Project	IEEE 802.16 Broadband Wireless Access Working Group < http://ieee802.org/16 >	
Title	Enhanced Broadcast/Multicast Capabilities of 802.16e	
Date	2004-06-25	
Submitted		
Source(s)	Yong Chang/Ph.D, Geun Hwi Lim/Ph.D B.S.Bae/Ph.D, D.K.Kim Samsung Electronic, Suwon P.O.Box 105, 416, Maetan-3dong, Paldal-gu, Suwon-si,Gyeonggi-do, Korea 442-742	yongchang@samsung.com
Re:	IEEE P802.16e/D3-2004	
Abstract	Enhanced broadcast/multicast capabilities of 802.16e.	
Purpose	Review and Adopt the suggested changes into P802.16e/D3	
Notice	This document has been prepared to assist IEEE 802.16. It is offered as a basis for discussion and is not binding on the contributing individual(s) or organization(s). The material in this document is subject to change in form and content after further study. The contributor(s) reserve(s) the right to add, amend or withdraw material contained herein.	
Release	The contributor grants a free, irrevocable license to the IEEE to incorporate material contained in this contribution, and any modifications thereof, in the creation of an IEEE Standards publication; to copyright in the IEEE's name any IEEE Standards publication even though it may include portions of thi

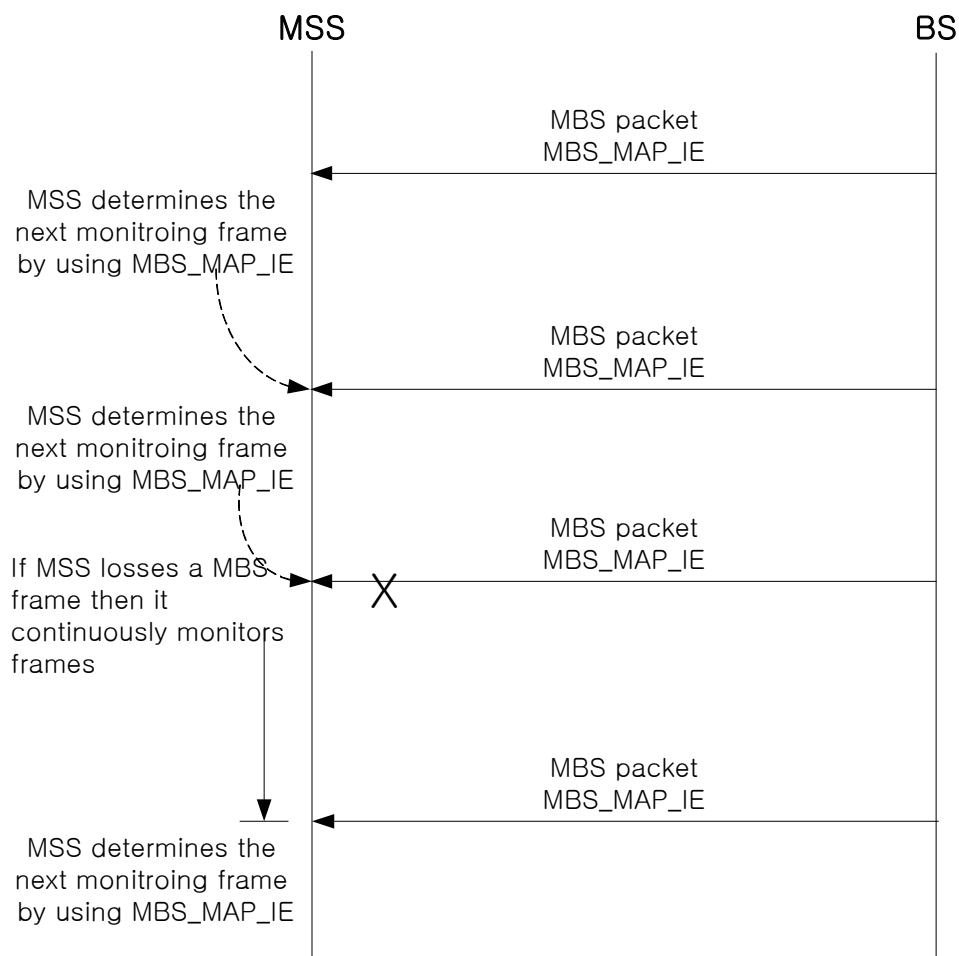
The MSS determines when to awake from the idle mode and to monitor next frame after reading MBS MAP IE. After receiving the frame at the time that the next frame scheduled to be transmitted over the air, the MSS repeats to read the MBS MAP IE for

next frame to receive. However, if the MSS loses one or a few frames at that time that the next frame is scheduled to be transmitted, then the MSS continuously monitors consecutive frames till MSS reads the MBS_MAP IE (see figure x.x.x)
